RBG-47861

SUBJECT: Response to License Renewal Application NRC Request for Additional Information

Sets 14,15 and Operating Experience Review Clarification, River Bend Station,

# REQUEST FOR ADDITIONAL INFORMATION LICENSE RENEWAL APPLICATION

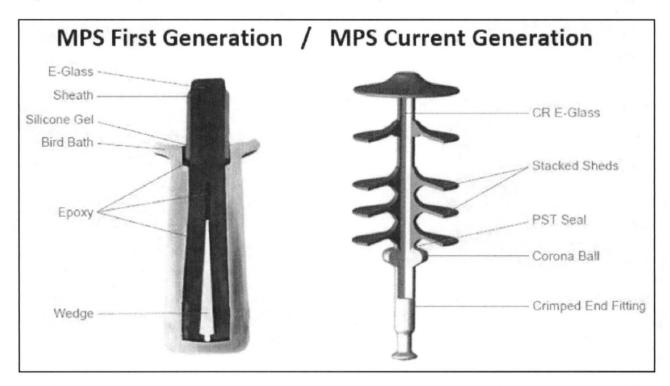
- 1. Explain why epoxy, silicone gel, sealants, and ductile iron are not listed in the response to RAI 3.6.2.2.2-1 as materials that are used in construction of polymer high-voltage insulators.

The RBS polymer high-voltage insulators are a recent generation of MPS polymer insulators that have been manufactured since 2007. The RBS polymer insulators do not use epoxy. The following figure shows the difference between the first generation of MPS polymer insulators and the generation of MPS polymer insulators that are used at RBS.

The MPS polymer insulators in service at RBS use a PST sealing system, which is a triple seal design. The triple seal or PST seal comprises the primary seal (P), the secondary seal (S), and the tertiary seal (T). The primary seal is a silicone rubber sheath compressed into the chamfer of the crimped end fitting. The secondary seal is RTV (room temperature vulcanizing) silicone applied to the rod, sheath, and end fitting interface. The tertiary seal is a final external RTV silicone seal applied to the sheath and end fitting interface. The RBS polymer insulators do not utilize silicone gel. The response to RAI 3.6.2.2.2-1 included silicone rubber, but did not explicitly identify RTV silicone as a type of silicone rubber. The silicone rubber material includes the RTV silicone that is part of the PST seal system. The RBS polymer insulators do not include silicone gel or sealants other than RTV silicone.
